ARCHITECTURAL REVIEW BOARD STAFF REPORT

Project #/Name	ARB-2023-36: Fifth Street Landing Self Storage Facility Major Amendment
Review Type	Major Amendment
Parcel Identification	07600-00-00-055A0
Location	On the south/east side of 5 th Street, south of Moore’s Creek, east of the Holiday Inn, west of Biscuit Run, and north of I-64
Zoned	Highway Commercial (HC), Entrance Corridor (EC)
Owner/Applicant	FTV Investments LLC/Shimp Engineering (Rachel Moon)
Magisterial District	Scottsville
Proposal	To construct a 100,800 sq. ft. self-storage building with associated site improvements on approximately 4.07 acres.
Context	The site is located in an area of mixed development. Building A (see Figure 2), from SDP2017-12 Fifth Street Commercial development, has been built and is located to the northwest. Two hotels are in the immediate area with a Holiday Inn located directly adjacent to the west and a Sleep Inn and Suites located northwest across 5 th Street. 5 th Street Station is located to the east and the Christian Aid Mission is located west across 5 th Street. Moore’s Creek borders the site on the north and Biscuit Run is nearby to the west. The border between the County and the City of Ch

Figure 2: ARB2023-36 Fifth Street Landing Self Storage Landscape Plan (left) and SDP2017-12 Fifth Street Commercial approved Landscape Plan (right).

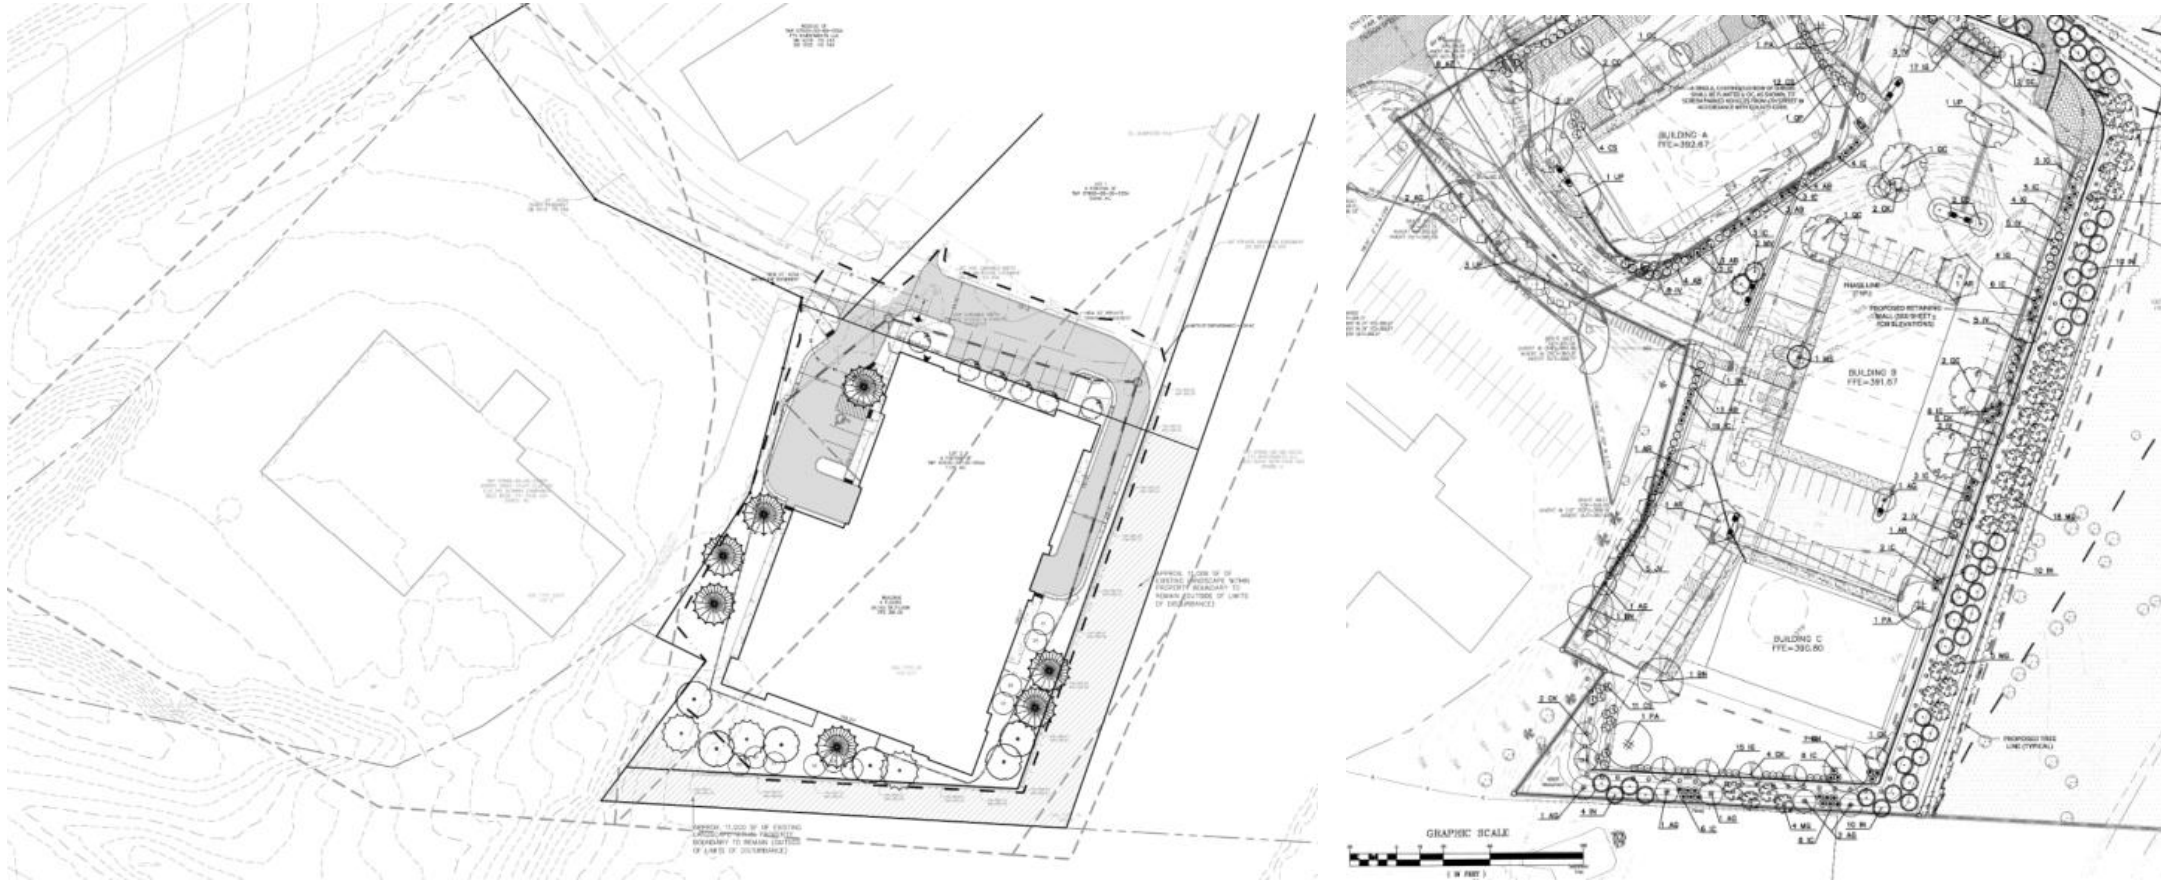
The proposed building is located at the rear of the site with its footprint encompassing Building C and a portion of Building B in the approved site plan for the Fifth Street Commercial development. (Fig. 2). The ARB reviewed and provided preliminary comments on the initial site plan at the October 3, 2022, ARB meeting. At that meeting, the Board also provided preliminary comments on a revised building design brought by the applicant (Figs. 3 and 4). A Special Exception to waive the requirement that the fourth story be stepped back 15’ on the front elevation (west) was approved on November 2, 2022.
